VERIDIAN AT COUNTY FARM SOUTH

PART OF THE VERIDIAN COUNTY FARM P.U.D. CITY OF ANN ARBOR, WASHTENAW COUNTY, MICHIGAN PUD SITE PLAN AMENDMENT #2

SITE PLAN AMENDMENT #2

PHASING PLAN

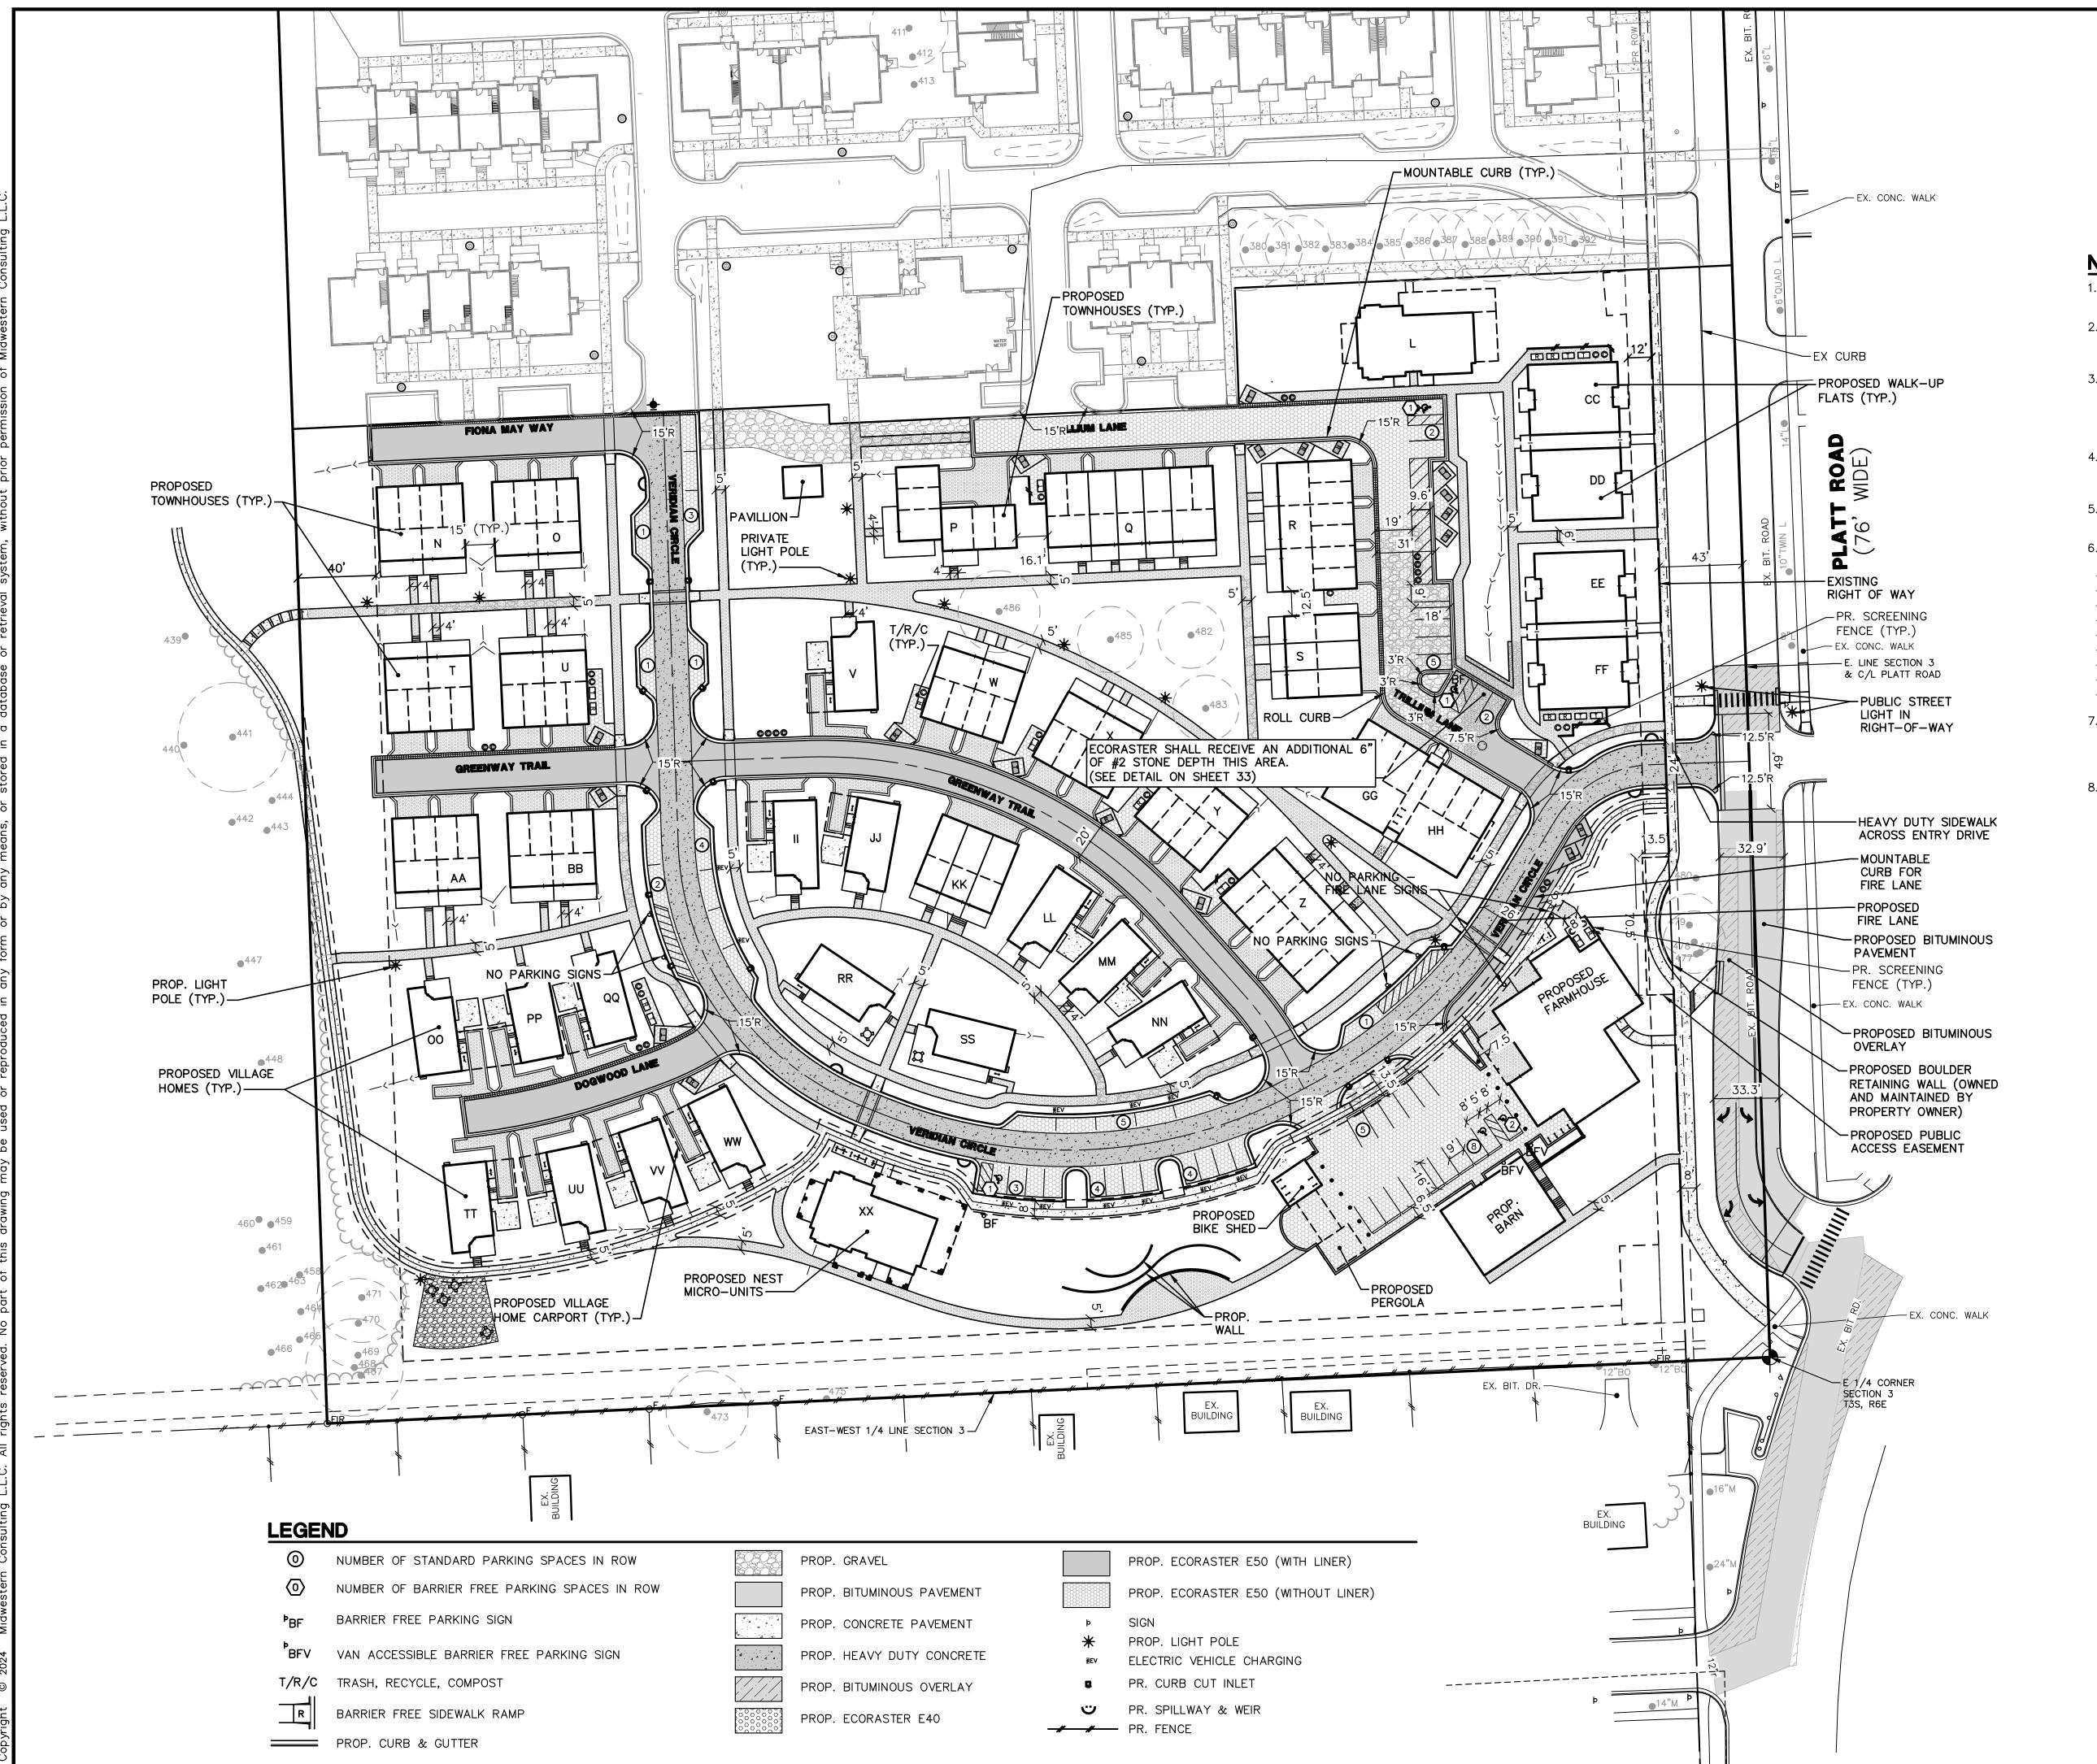
the Village Homes, adding carports to the Village Homes and modifying the pavement surfaces to reflect the additional installation of pavers. The proposed school has been

The stormwater management systems have been revised to account for the change in impervious surfaces and also approximately 20% of the total underground detention basin storage volume has been relocated. This relocation reduced the basin volume for underground detention "B" with a corresponding increase in storage provided in underground

The purpose of the site plan amendment is to convert the single family units L & M into multifamily residential units, and to convert KK into a triplex. Parking and drive configuration is revised in the northeast portion of the site to provide for additional open space. Unit V has been converted from a triplex to a village home due to unsuitable soil conditions found at the

The purpose for this administrative amendment is to reconfigure the driveways and parking for removed from the proposal and 11 additional micro units have been added to that space. The 11 additional micro units are proposed to be built in Phase 2 of the project.

Stormwater management systems have been updated to eliminate the large bioswale in the northeast portion of the site and to replace it with an underground stone infiltration bed. The installation of pervious roadways surfaces have also been incorporated to allow for increased infiltration of stormwater.
